Metropolitan Planning Commission

**Part B Subdivisions & PUD
UDO Request**

Staff Reports

April 24, 2008

Site Plan

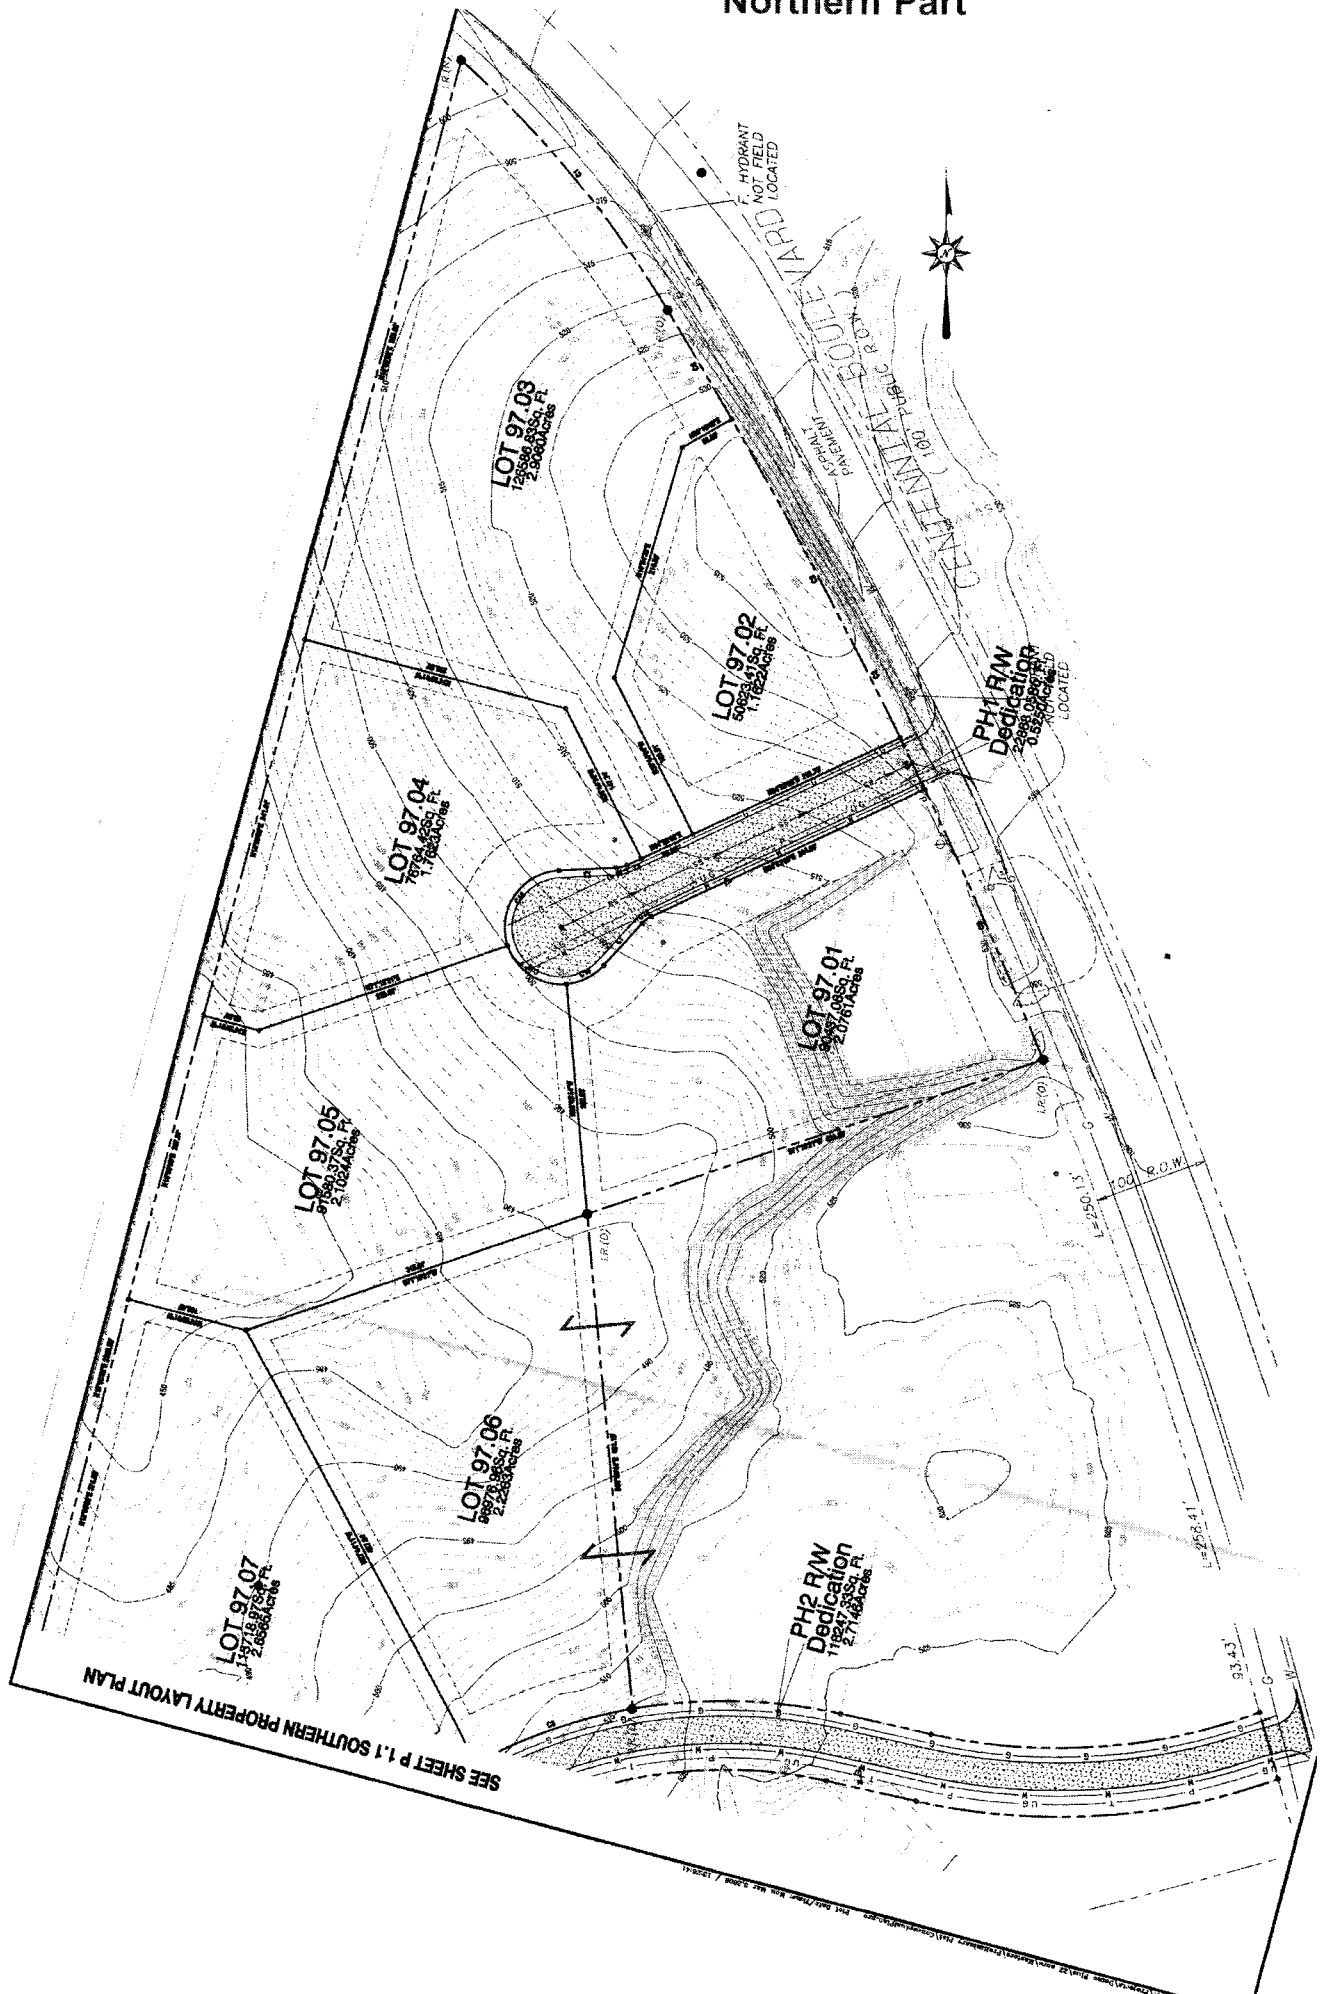
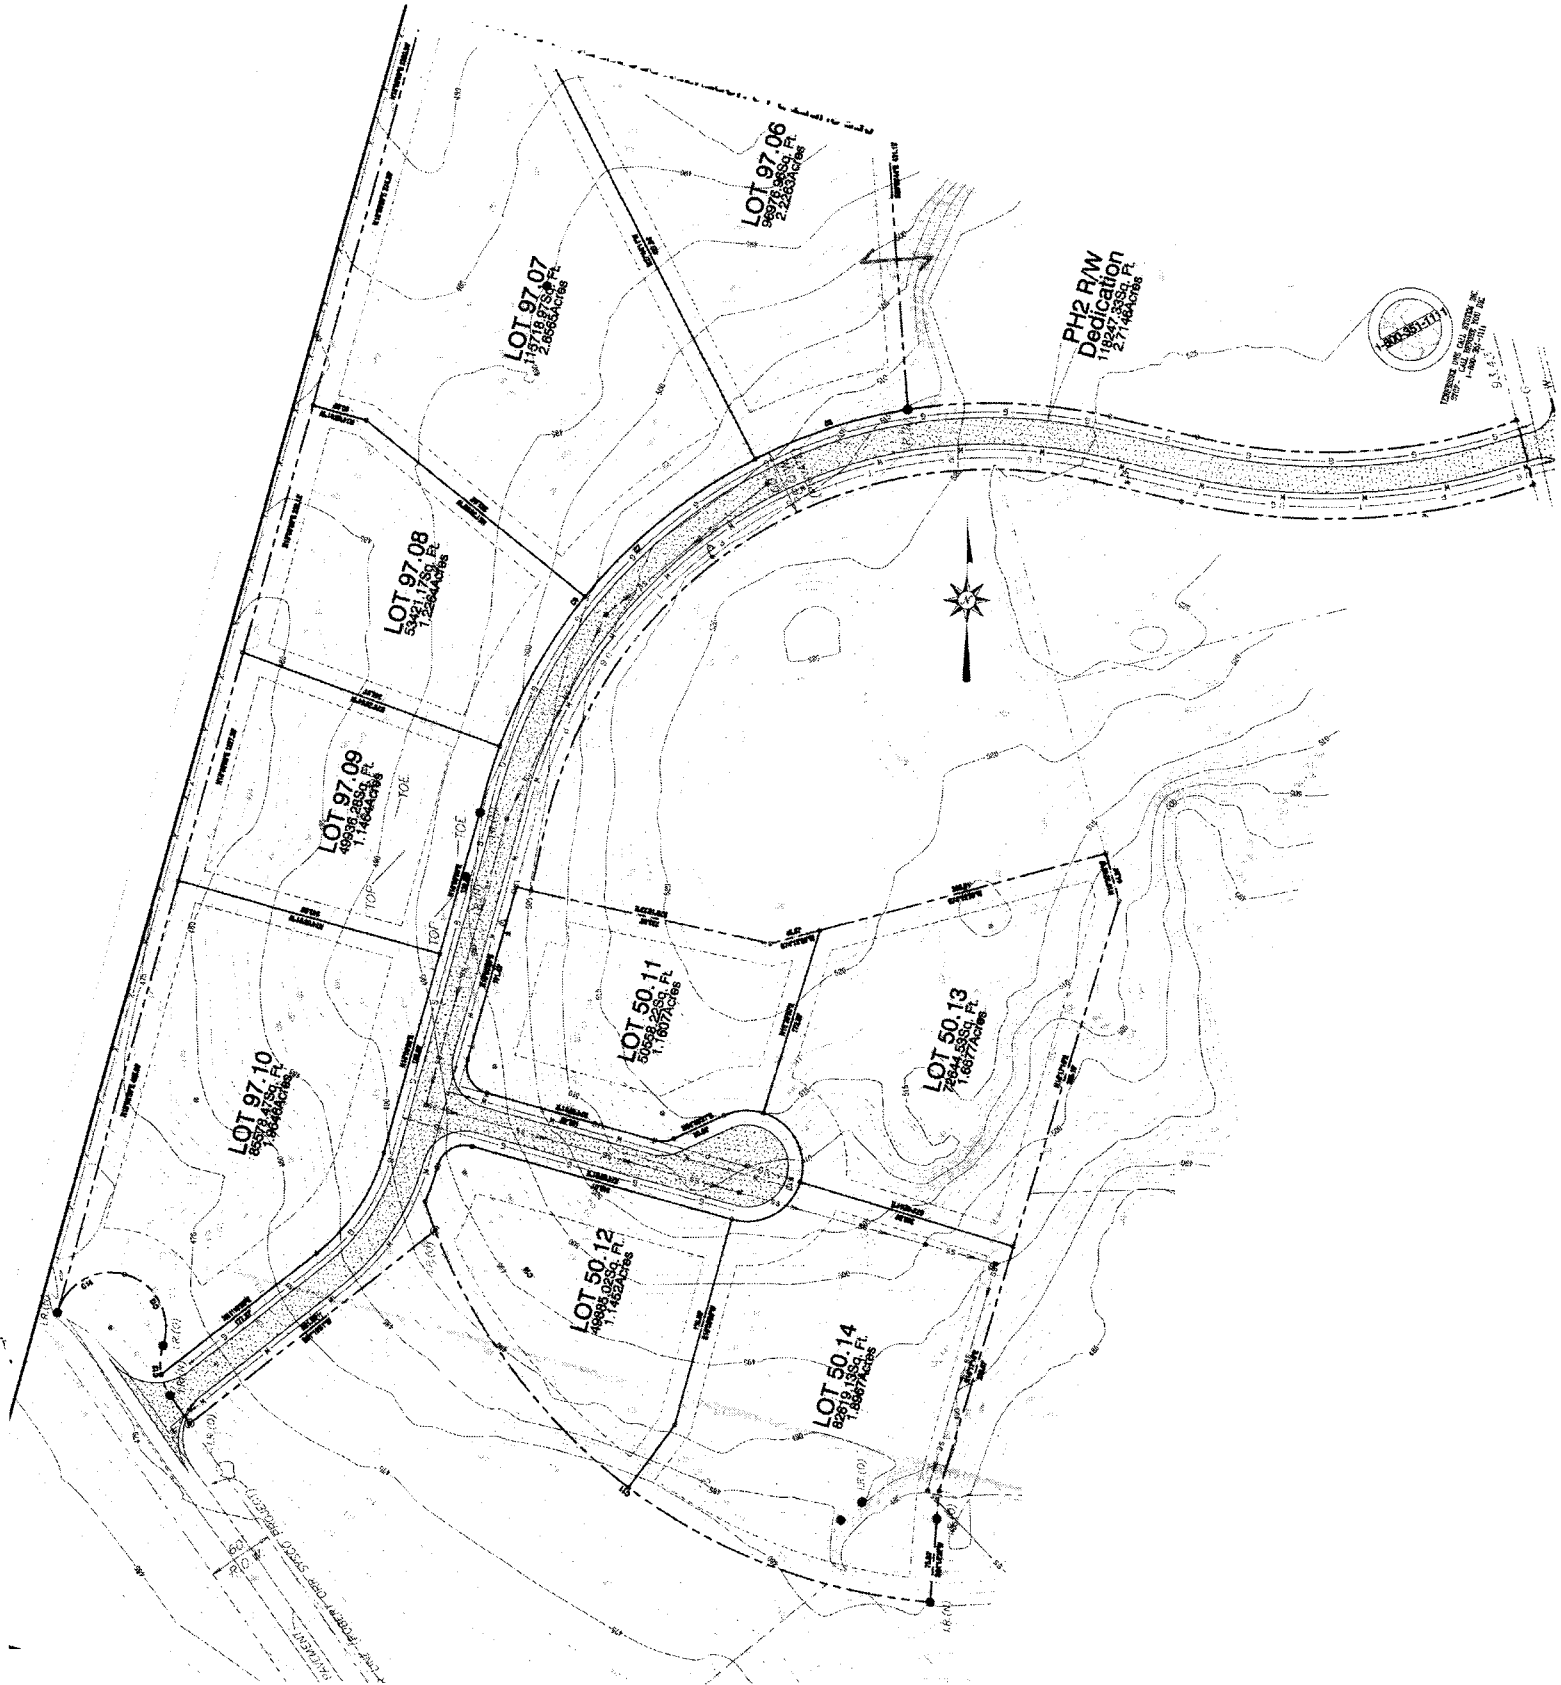
Metro GIS shows closed contours on the property, and indicates the likely presence of sinkholes. The Subdivision Regulations do not specifically disallow sinkholes within lots that are not zoned residential; however, the Commission does have the authority to

determine if land is suitable for development (Section 3-3). Since this is not a residential district sinkholes *may* reside within lots, however, more detail is needed to determine if the presence of sinkholes within lots could cause future problems. In order to address this issue, a geotechnical study shall be prepared and submitted with the Development Plan. The report must verify if sinkholes are present and if present how they are to be treated. Furthermore, lots shall be designated as critical lots and a note indicating the presence of sinkholes shall be placed on any future final plat.

1. Metro GIS indicates the presence of a stream that runs parallel to Lots 97.02 and 97.03. The stream continues north running parallel to Centennial Blvd. As such, show and label the Stream Tops of Bank. Furthermore, Show and Label a 30', "Water Quality Buffer" for said Stream. The Water Quality Buffer is scaled from the stream Tops of Bank. The total required buffer width is 30' + 30' + the top width of channel.
2. A Water Quality Concept is conspicuously absent from the plan. Show and Label a Water Quality Concept. Appropriate correction is required.

1. The developer's construction drawings shall comply with the design regulations established by the Department of Public Works.
2. Prior to the submittal of construction plans, provide documentation of adequate sight distance at project entrances.
3. Roadway section and schedule per standard drawing ST-260.
4. Prior to the submittal of construction plans, the applicant shall provide a geotechnical study to support roadways with fill material, and document the fill slope stability along the public right of way.
5. Along Centennial Boulevard, begin fill slope outside of the public right of way.
6. A TIS may be required at the time of development.

1. A geotechnical study must be prepared and submitted with the Development Plan. The report must verify if sinkholes are present and if present how they are to be treated.

2. Lots with sinkholes shall be designated as critical lots, and a note shall be added to any future final plat indicating the presence of sinkholes.
3. Re-label lots 1-14.

4. Correct phasing plan. It shows 15 lots when the plan is for 14 lots.
5. Metro GIS indicates the presence of a stream that runs parallel to Lots 97.02 and 97.03. The stream continues north running parallel to Centennial Blvd. As such, show and label the Stream Tops of Bank. Furthermore, Show and Label a 30', "Water Quality Buffer" for said Stream. The Water Quality Buffer is scaled from the stream Tops of Bank. The total required buffer width is 30' + 30' + the top width of channel.

6. A Water Quality Concept is conspicuously absent from the plan. Show and Label a Water Quality Concept. Appropriate correction is required.
7. The developer's construction drawings shall comply with the design regulations established by the Department of Public Works.

8. Prior to the submittal of construction plans, provide documentation of adequate sight distance at project entrances.
9. Roadway section and schedule per standard drawing ST-260.

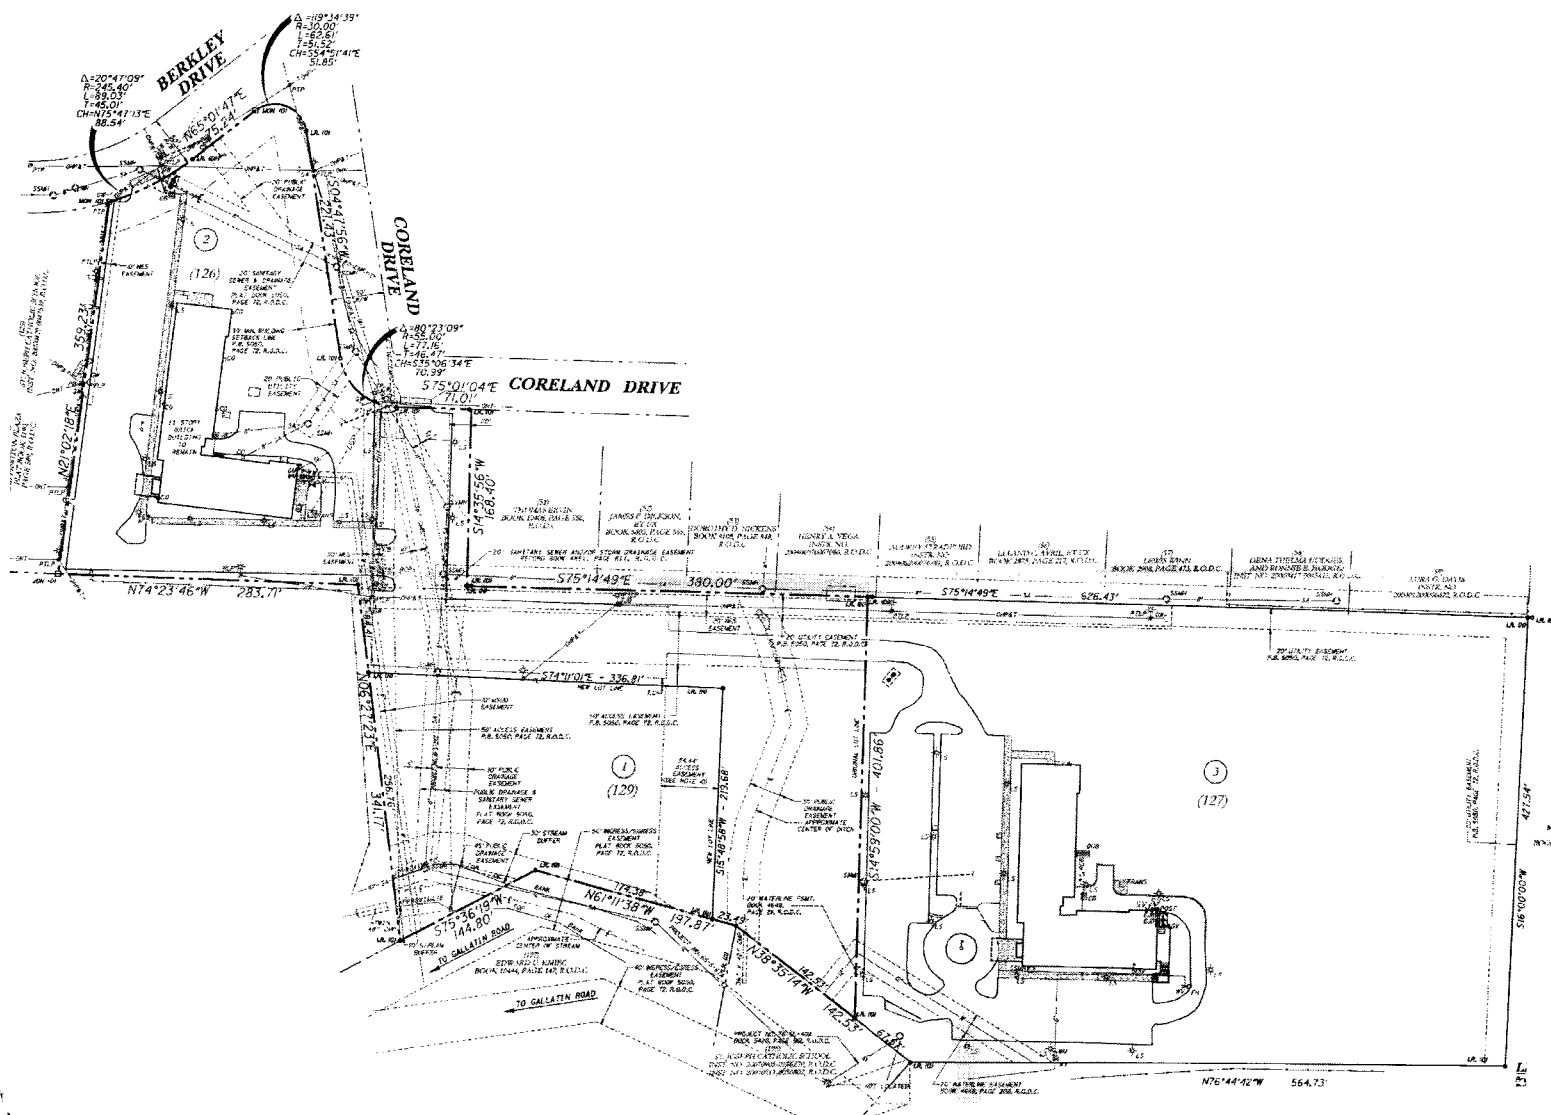
Prior to recording the final plat, the following revisions need to be made:

1. Show all three lots within the boundary of the plat.
2. Revise purpose note to reflect the correct number of lots.
3. Delete note 16, which incorrectly references PUD requirements.
4. Add lot size for Lot 3.
5. Submit a plan stamped by Madison Utility District.

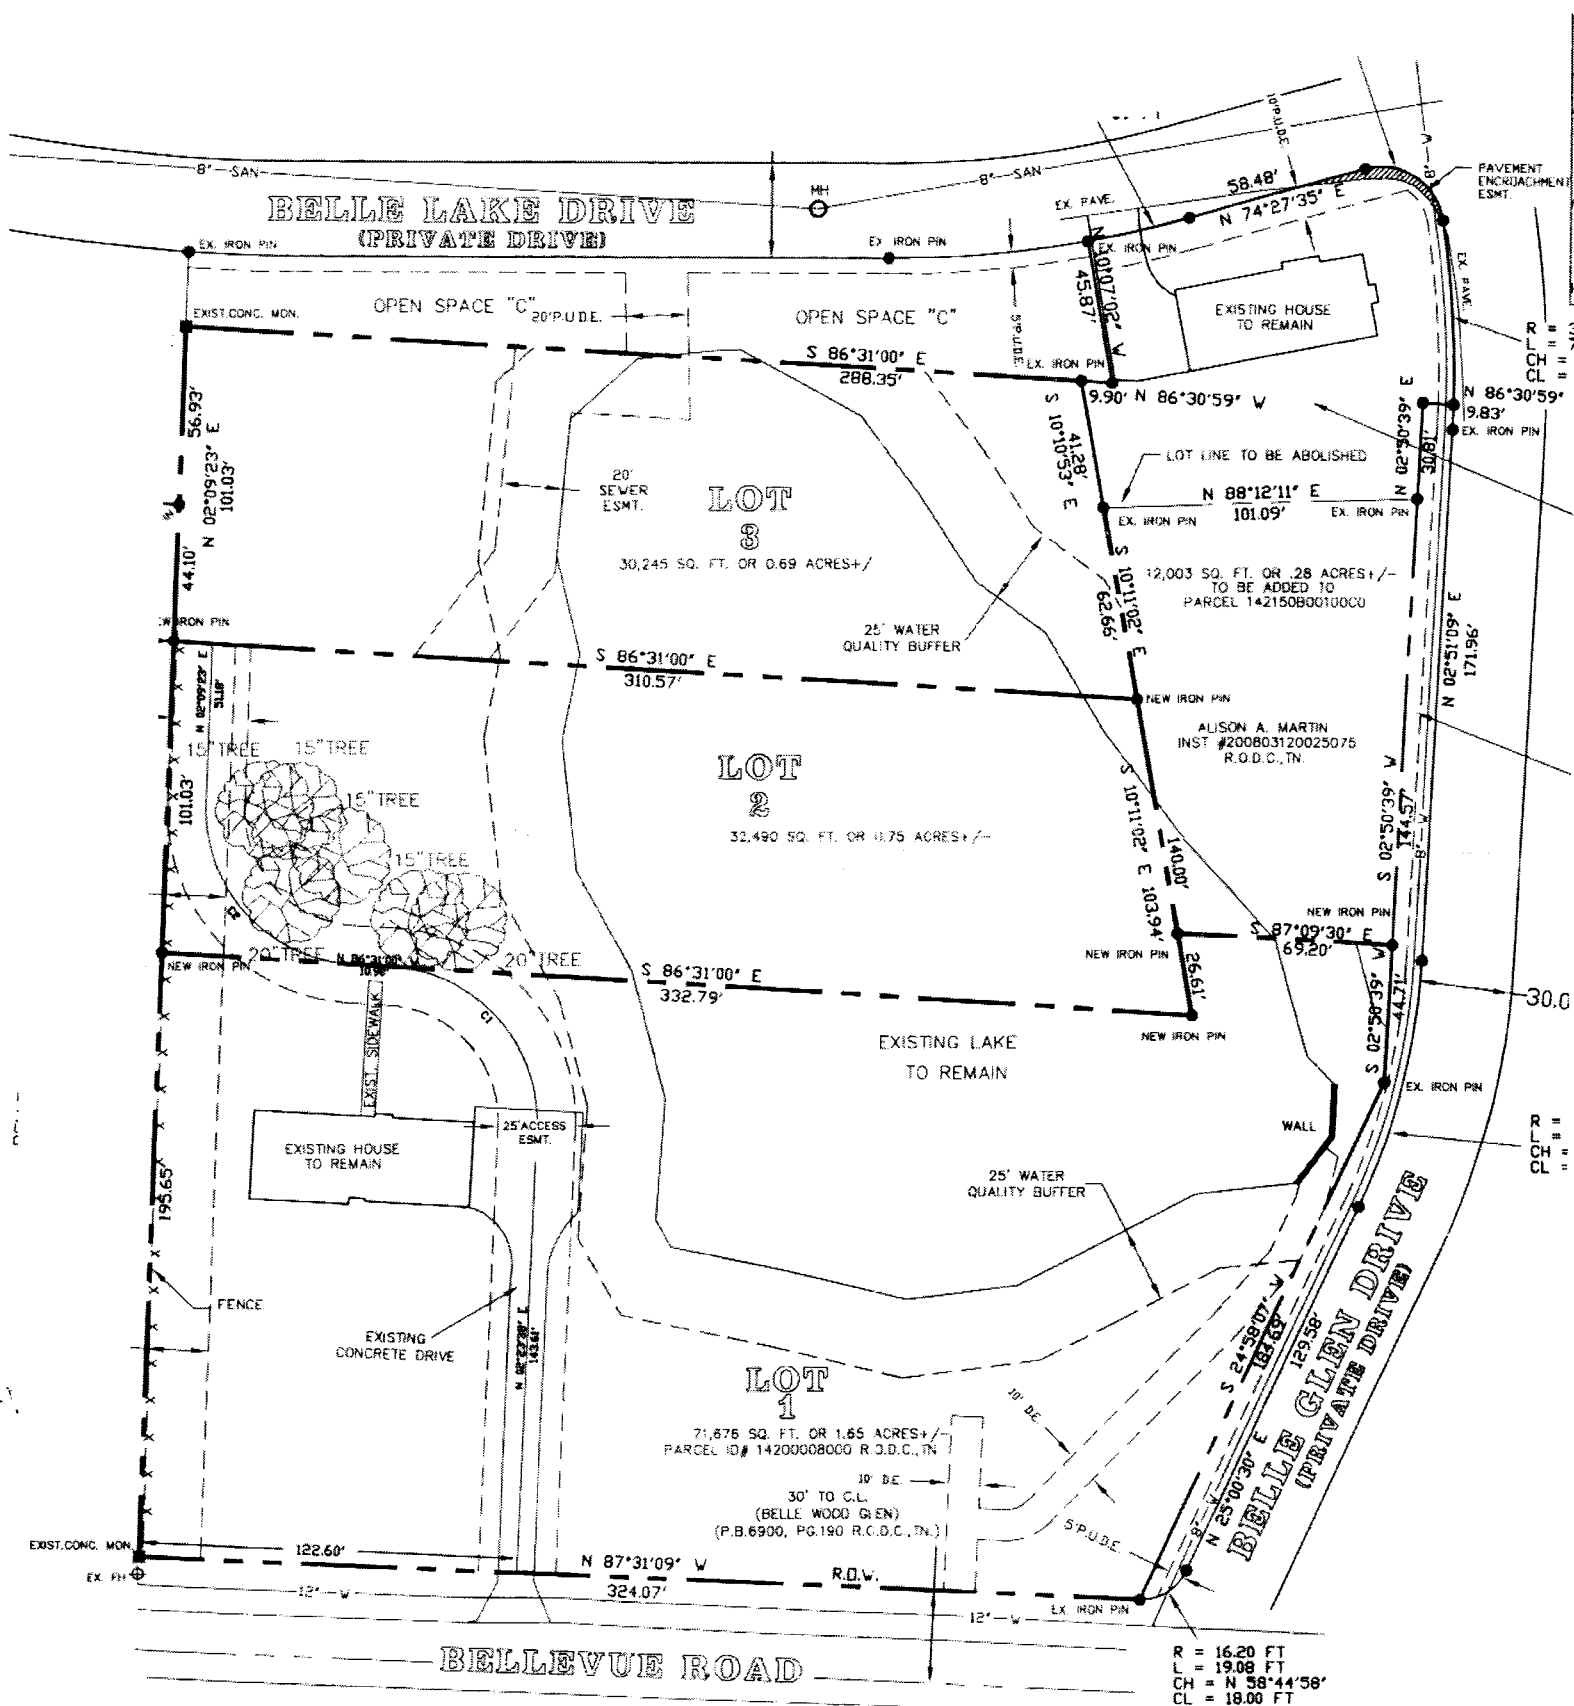
Section 3-4.2.b of the Subdivision Regulations requires all residential lots to have street frontage. This request creates two lots with no street frontage. The applicant has submitted a variance request stating that the lake, existing house, and private drives create a hardship for developing this property. However, these conditions were created by the owner or the previous owners. The PUD that limits the access was subdivided from a larger parcel that also included this property. Additional access was eliminated by that subdivision. Self-made conditions do not constitute a hardship.

It may be appropriate to permit the development of one additional lot. The additional lot could be accommodated without dividing ownership of the lake, which would eliminate maintenance issues with multiple owners. An access easement may also be sufficient access for one lot. Two additional lots is an

inappropriate increase in density for this property because a pond on this site diminishes the useable acreage, and because of the limited ability to gain access to property with no street frontage.

Identify owner of Open Space "C".

1. Revise to show two lots, with the entirety of the lake within one lot or common open space.
